D/DRC Case

DESIGN/DEVELOPMENT REVIEW COMMISSION
DESIGN REVIEW DISTRICT
EVALUATION SHEET
Case # 2

ADDRESS: 1400 Lady Street

NATURE OF REQUEST: This is a request for Certificate of Design Approval for renovations to an existing building.

CONCEPT SKETCHES FOR 1400 LADY STREET

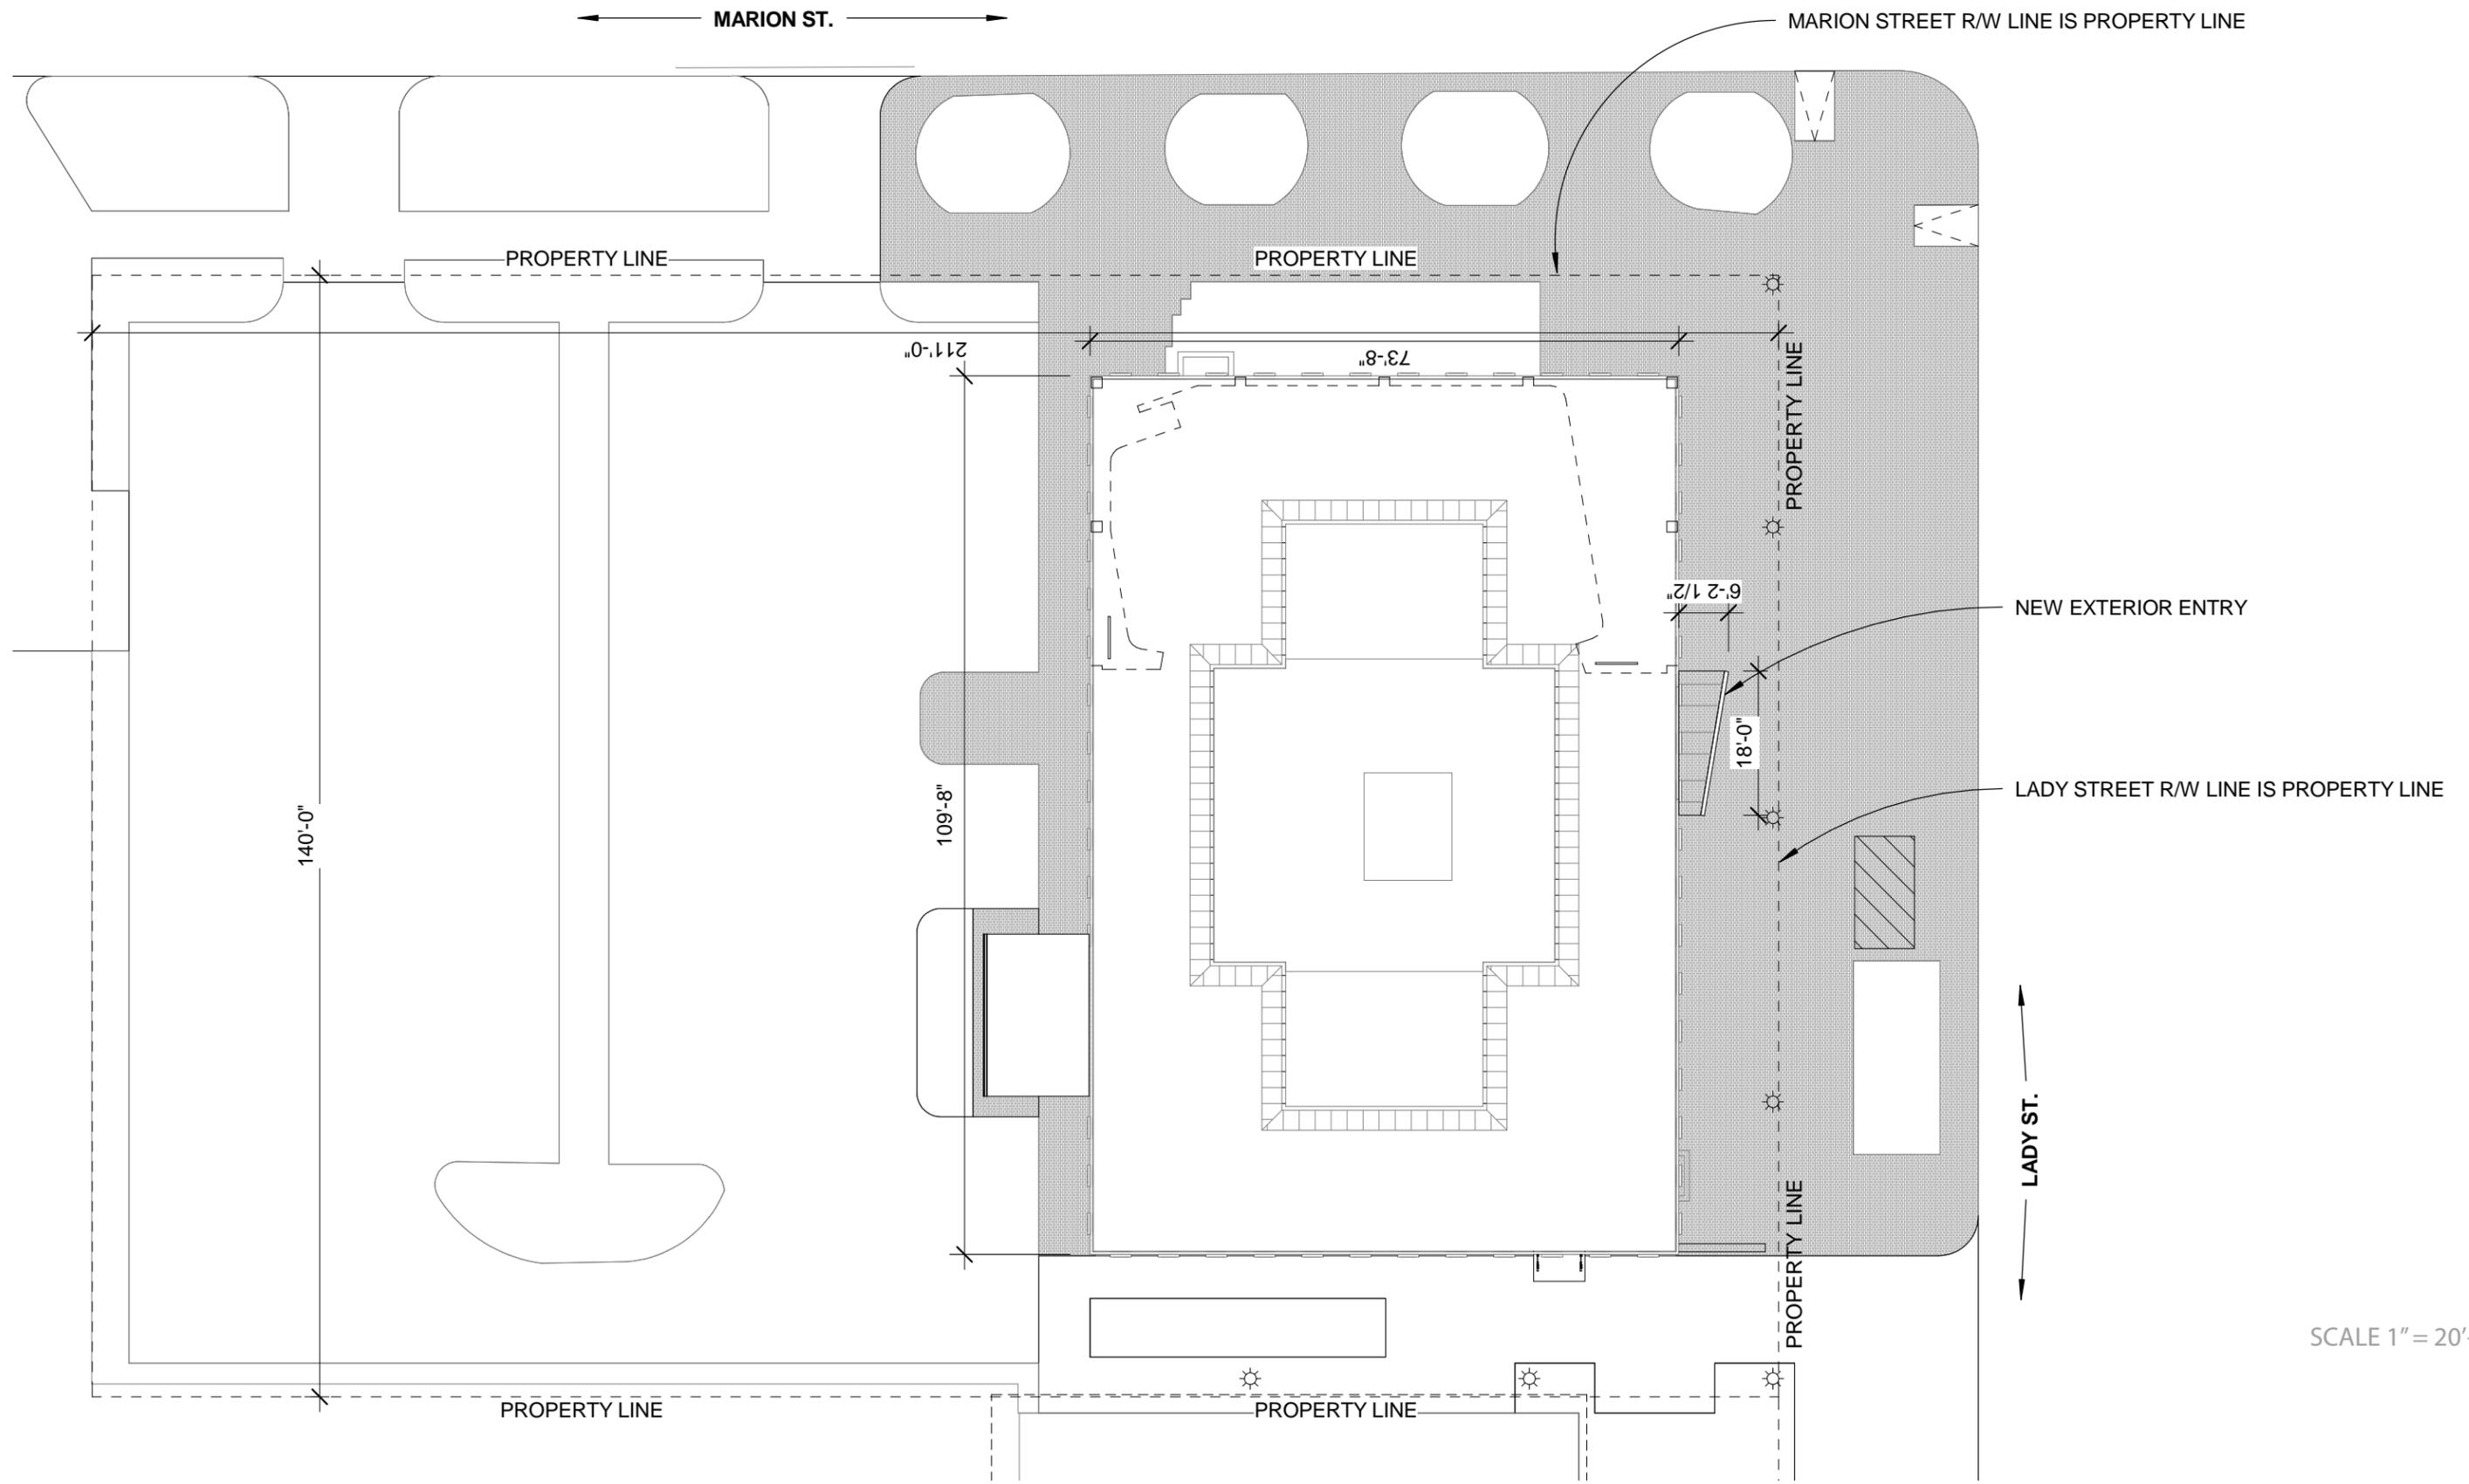
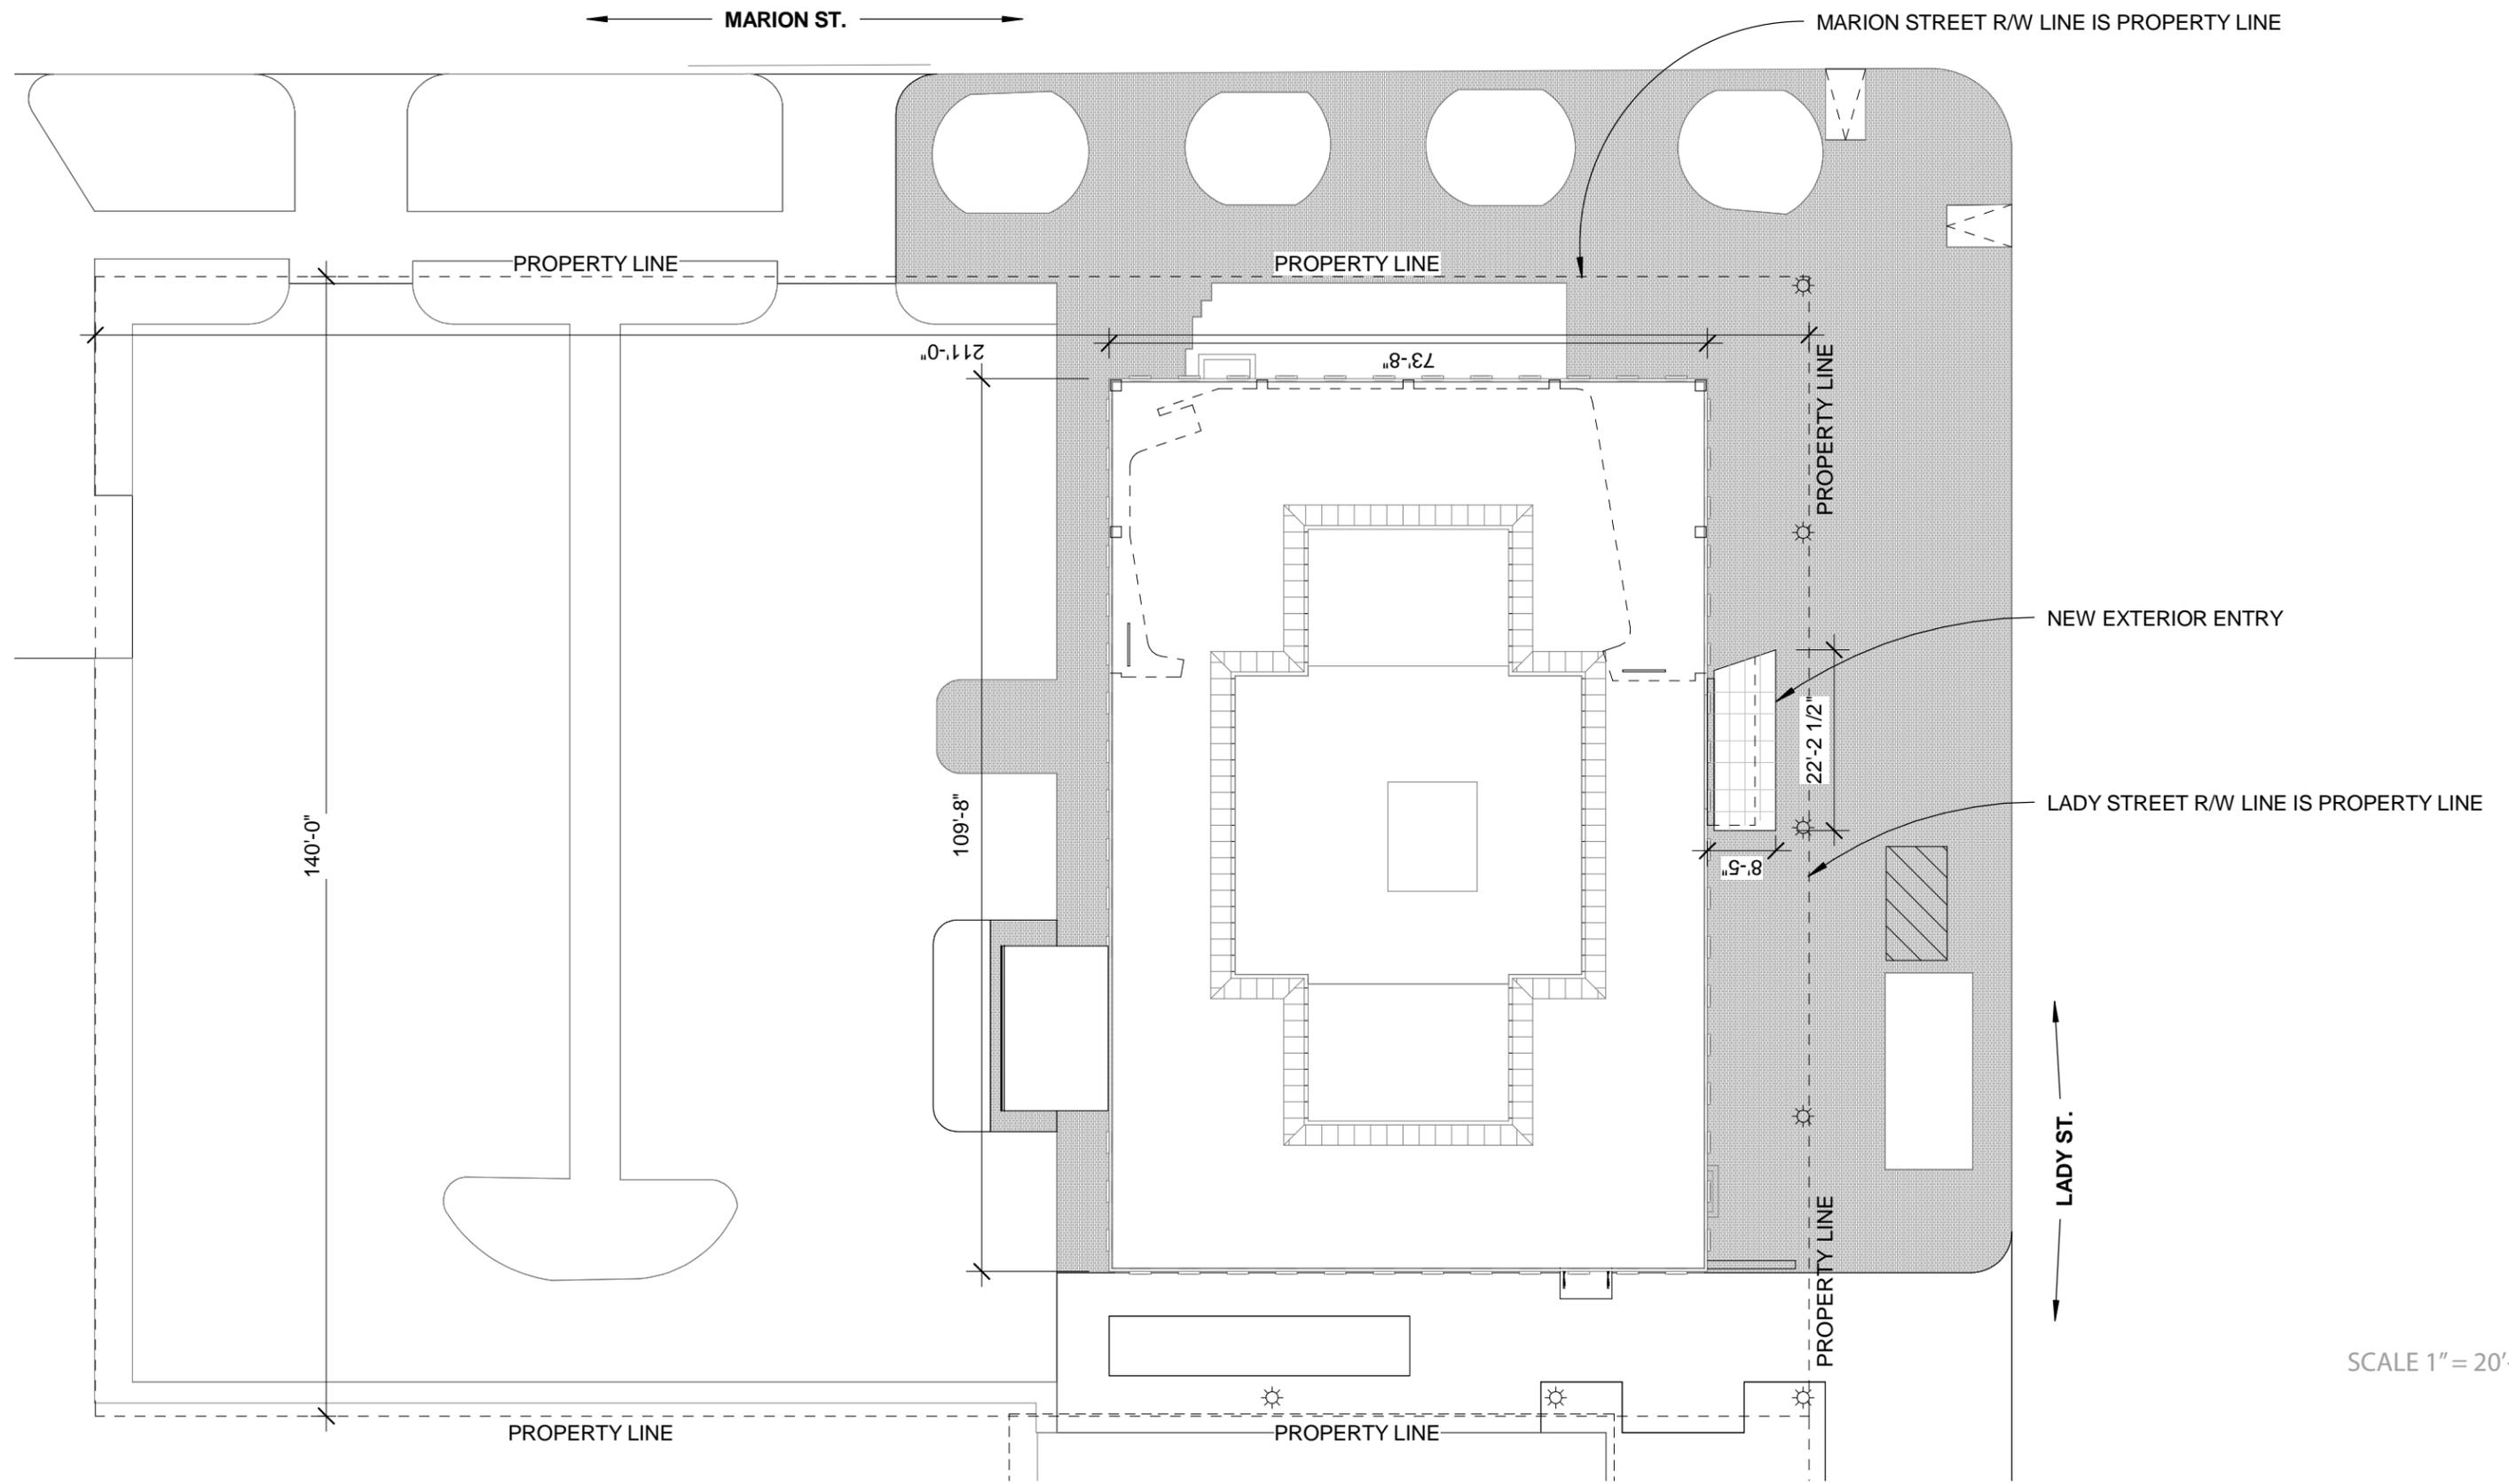
Option A adds an asymmetrical glass atrium to the front center of the building, and removes the window units and brick infill on the second and third floors, while leaving in place the pre-cast concrete frames.

Option B is similar, but slightly larger and has an additional wall system that defines the top and west sides of the atrium; this option also leaves the pre-cast concrete window frames in place.

Both proposals attempt to continue the repetitive pattern of the first and second floor windows by leaving in place their most defining feature- the pre-cast frames. As well, the atrium designs are distinct yet compatible additions that could theoretically be removed in the future.

The applicant has worked extensively, with staff, to try to find a compromise that would both meet the needs of the owner, while also meeting the design guidelines. However, despite these efforts, both designs disrupt the consistent pattern found on all four elevations of the building by removing the brick between the windows, a feature that is necessary to reading the pattern. The addition of the atrium, in both cases, further interrupts this strong, simple design concept of solids and voids that the extant window pattern presents throughout the building, but of particular importance on the primary façade.

Staff recommends denial of the request based on Section **5.9.4** *Window replacement*, as the removal of the original window openings does not meet this guideline, and **5.9** *Building Additions, Renovations, and Demolitions*, as the addition does not meet this guideline.
